State of New Mexico
Energy, Minerals and Natural Resources Department

30-039-06476 JICARILLA 110 #012
SOUTHLAND ROYALTY COMPANY LLC

Re: Permanent Abandonment
Well: Jicarilla 110 12 API: 30-039-06476

CONDITIONS OF APPROVAL

PROPOSED P&A

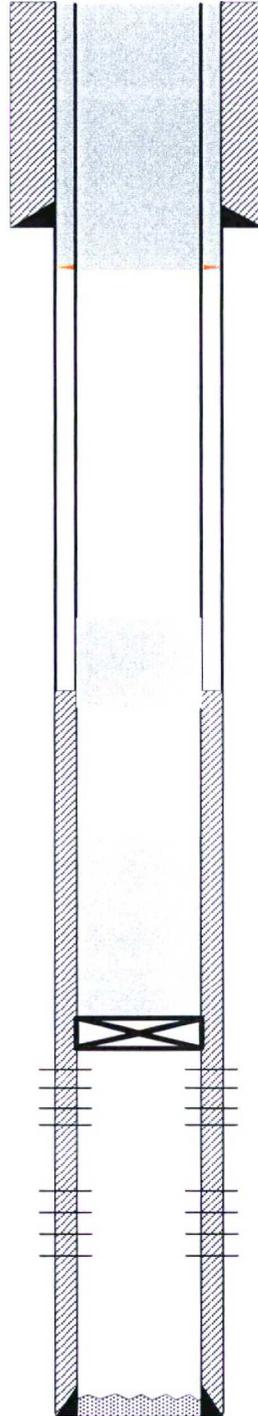
- Notify NMOCD 24hrs prior to beginning operations.
- Extend plug #1 to 3090'-2510' BLM Ojo Alamo pick @ 2588'
- Adjust plug #2 to 1218'-1350' to cover the Nacimiento top. BLM Nacimiento pick @ 1268'. OCD Nacimiento pick @ 1300'.

1. Plugging operations authorized are subject to the attached "General Requirements for Permanent Abandonment of Wells on Federal and Indian Lease."
2. Farmington Office is to be notified at least 24 hours before the plugging operations commence (505) 564-7750.
3. CBL required after setting CIBP from 3090' to surface to confirm TOC. Submit electronic copy of the log for verification to the following addresses: jkillina@blm.gov and Brandon.Powell@state.nm.us . Based on CBL results inside/outside plugs and volumes will be adjusted accordingly. Please review the General Requirements document to ensure volumes meet required excess inside and outside casing.
4. BLM picks formation tops as indicated in the table below for use in determining TOC for all plugs.
